## PROVIDENCE PARK ONE ACRE OFFICE BUILDING JSP14-87

Public hearing at the request of Whitehall Real Estate Interests for the approval of Preliminary Site Plan, Woodlands Permit and Stormwater Management Plan. The subject property is located in Section 17 in the south west corner of Grand River Avenue and Providence Parkway. The applicant, Whitehall Real Estate Interests, proposes to build a one story 6,660 square foot speculative general medical office building and associated parking facilities on the northwest corner of the Providence Park Hospital planned office complex site. The project fronts on Providence Parkway and is adjacent to Grand River Avenue.

# PLAN REVIEW CENTER REPORT

**Review Date:** April 21, 2015  
**Review Type:** Preliminary Site Plan  
**Project Name:** JSP14 – 87: Providence Park One Acre Office Building  
**Plan Date:** April 10, 2015  
**Prepared by:** Sri Komaragiri, Planner **E-mail:** skomaragiri@cityofnovi.org; **Phone:** (248) 735-5607

**Figure 1.** City of Novi Regulated Wetland & Woodland Map (approximate project boundary is shown in red). Regulated Wetland areas are shown in blue. The area of on-site wetland is over-estimated on the City Map.

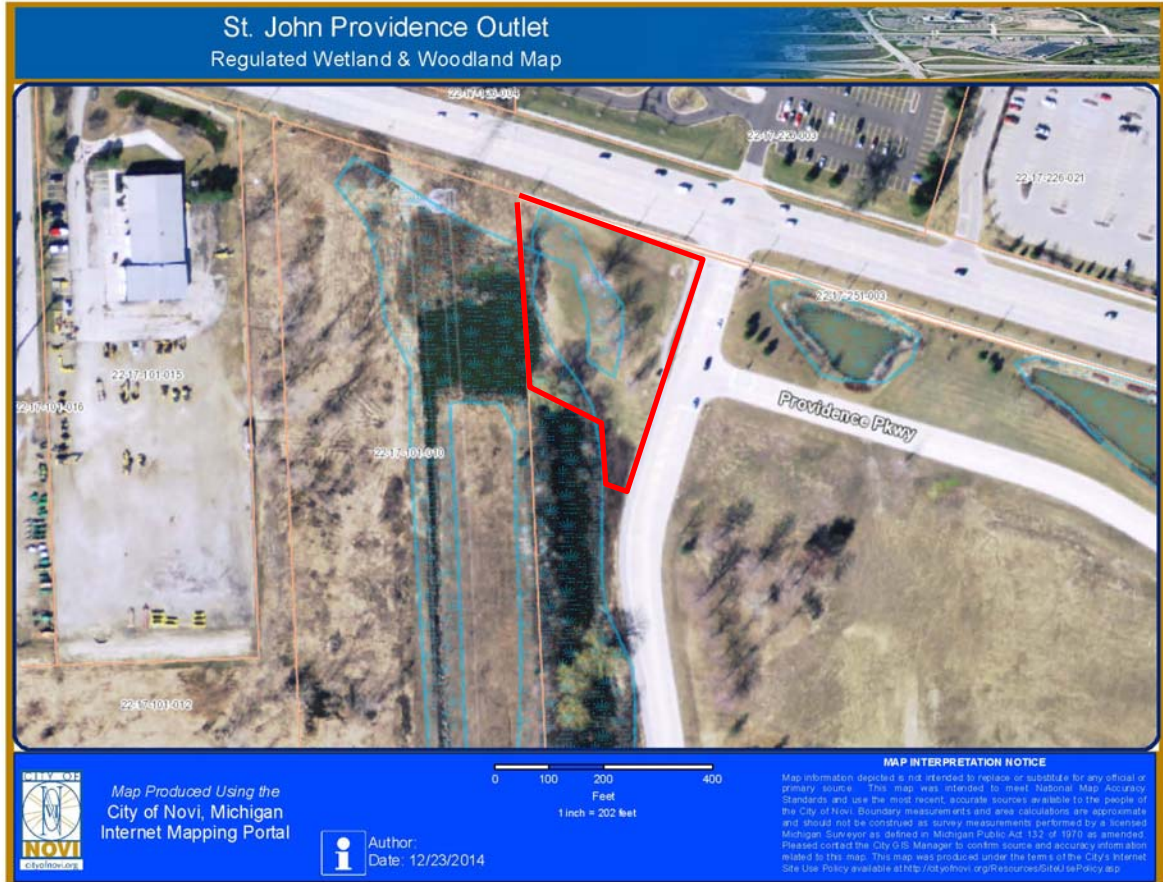
Based on our review of the Plan, Novi aerial photos, Novi GIS, the City of Novi Official Wetlands Map, and our on-site wetland evaluation, it appears as if this site contains City-regulated wetlands. The site plan indicates an area of existing wetland located along the western edge of the proposed project site (see Figure 1). This area consists of emergent as well as open-water wetland area. The *Landscape Plan* (Sheet L-1) notes that the site contains 7,275 square feet (0.17-acre) of wetland, but that no wetland impacts are proposed.

The Plan does appear to propose impacts to the 25-foot wetland buffer associated with this wetland. As such, the project would require a City of Novi *Authorization to encroach the 25-foot Wetland Buffer*. The *Landscape Plan* (Sheet L-1) notes that the site contains 7,548 square feet (0.17-acre) of wetland buffer. Of this, 3,120 square feet (0.07-acre) of permanent wetland buffer impact is proposed (160 cubic yards). As such, the Plan will permanently disrupt 41% of the existing 25-foot buffer.
